EXHIBIT A
FINAL ENVIRONMENTAL IMPACT REPORT (FEIR)
ERRATA AND SUPPLEMENT
May 2007 (Revised July 2007)

This exhibit serves as an errata and supplement to the Village at Loch Lomond Marina Final Environmental Impact Report (FEIR). The following information was either not included or referenced in the FEIR or is being edited for correction:

AM Travel Time: Special Route 11 (Pt. San Pedro@Lochinvar - Hetherton - 101SB)

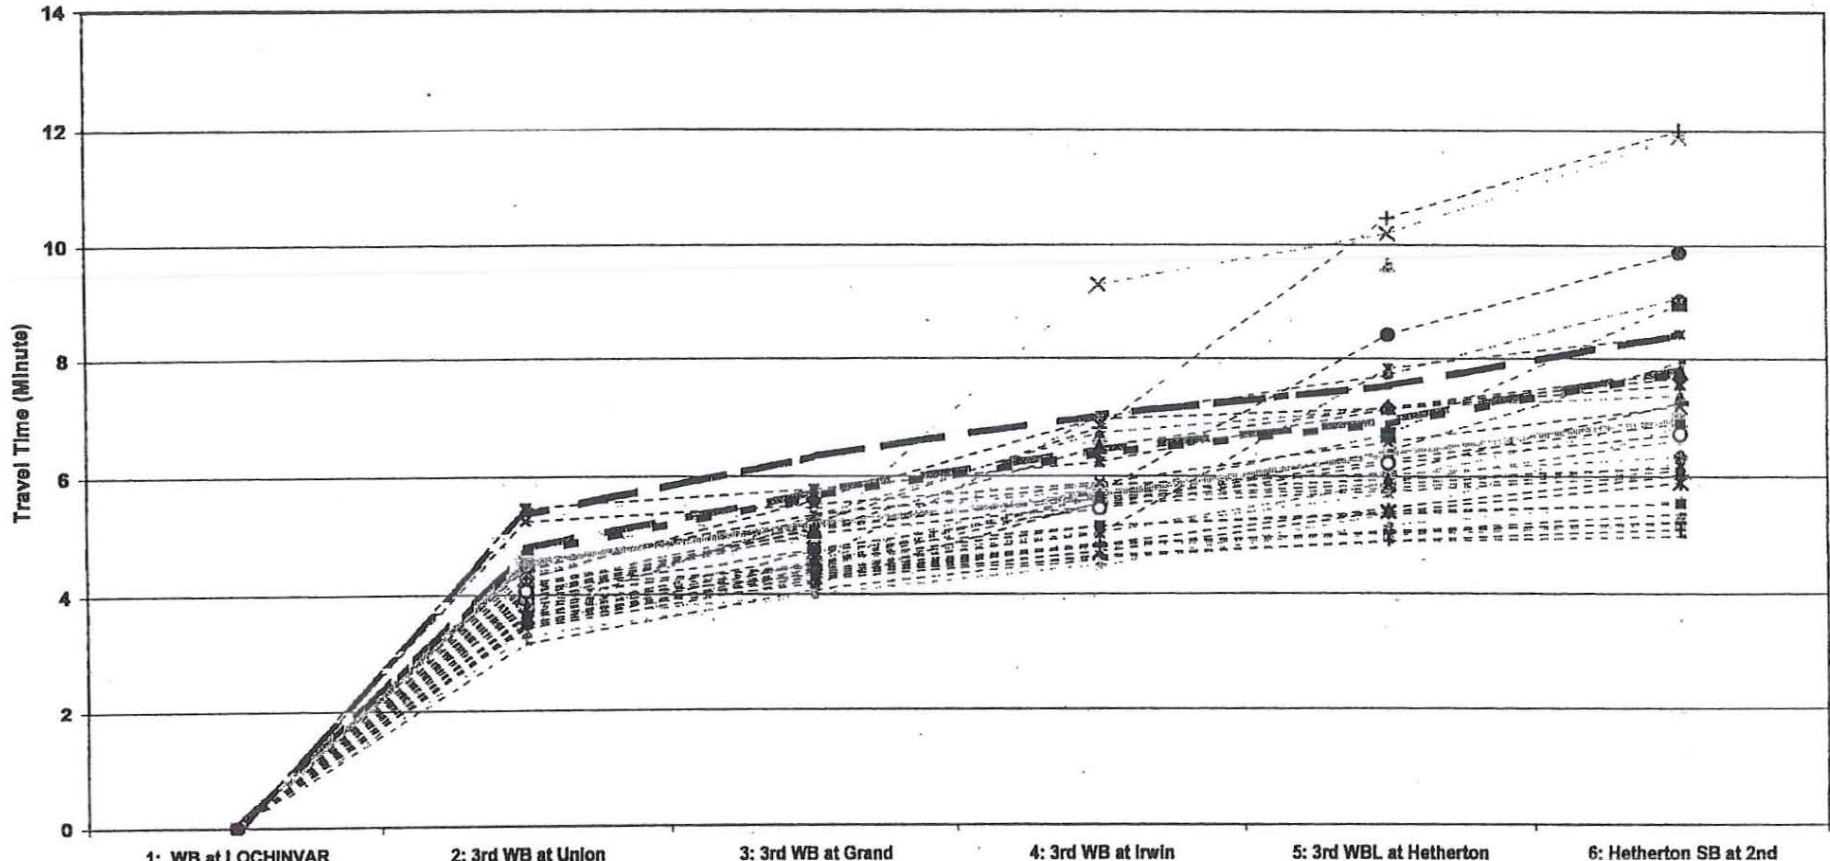
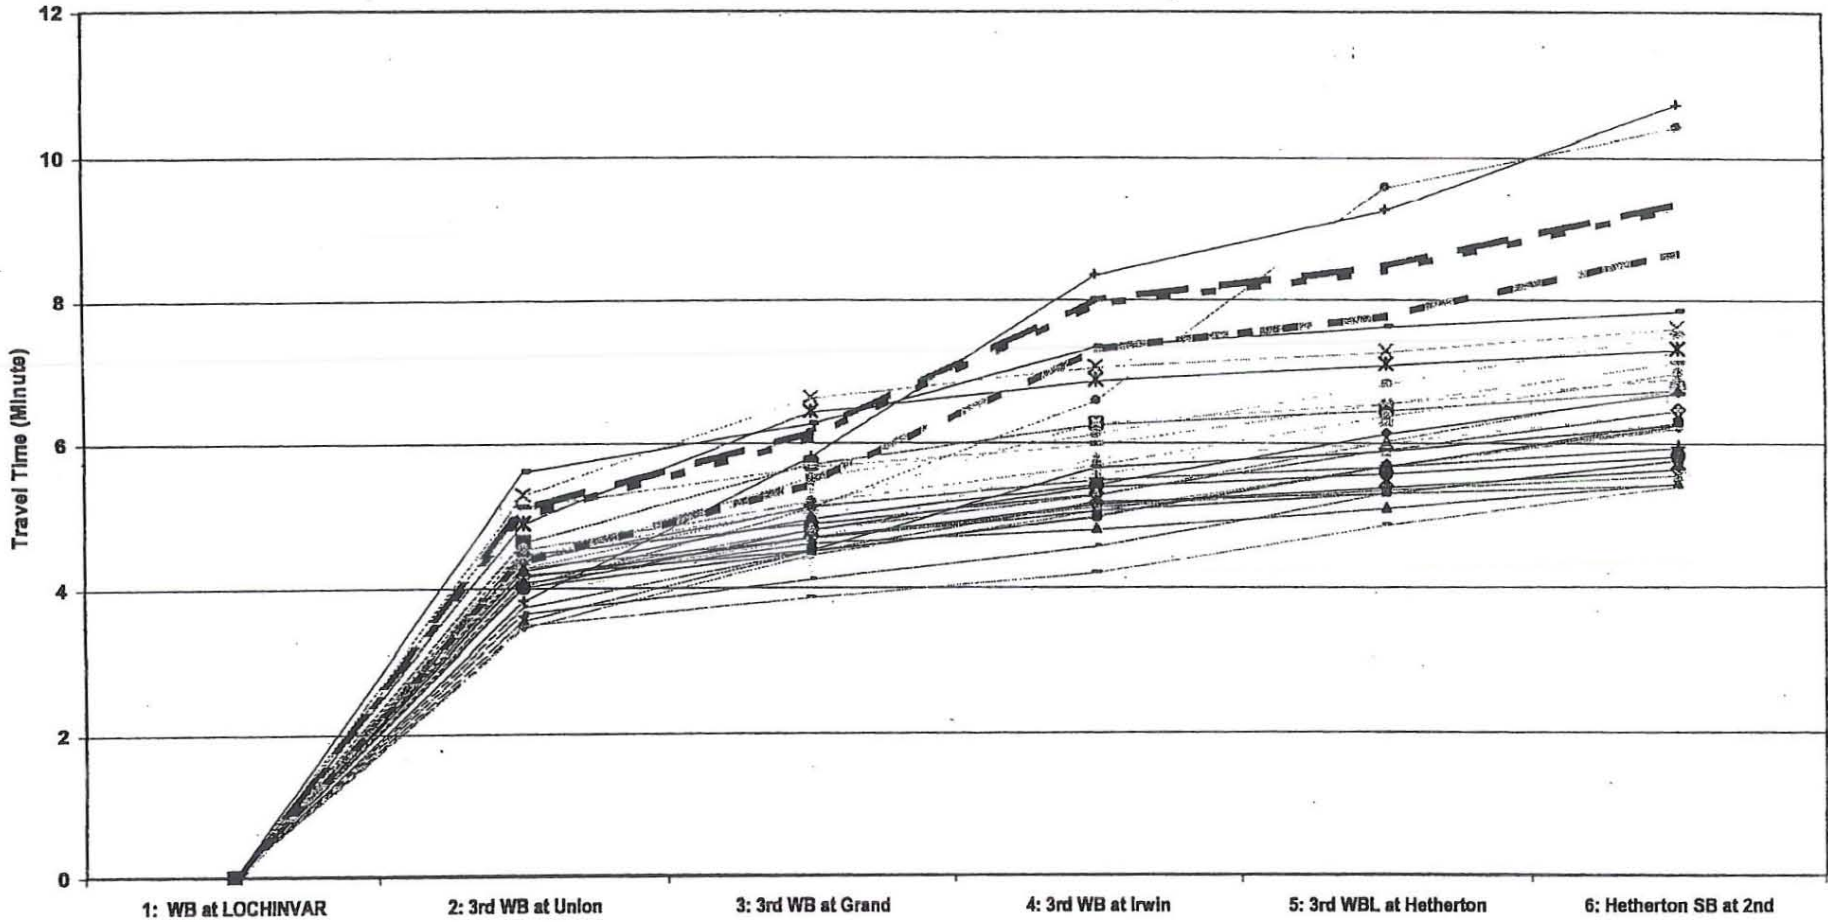
2. Expand FEIR Volume IV, Section 2.0, Master Response TRF-1 (Traffic), addressing average vehicle travel time between the project site and the US 101 on-ramps and off-ramps (Volume IV, page 2.0-14). This response did not include an estimate on how the addition of project traffic would impact the estimated travel time. The City Traffic Engineer has been consulted and has provided the travel time charts that were prepared for the September 12, 2006 Planning Commission study session (attached). The City Traffic Engineer reported that based on tested 'travel runs' between the project site and US 101, the travel time is 5-12 minutes in the AM peak hour 6-11 minutes in the PM peak hour. As presented on the time charts, the addition of project traffic (Phase I and Phase II) would not measurably increase travel time between US 101 and the project site during the AM or PM peak hours.
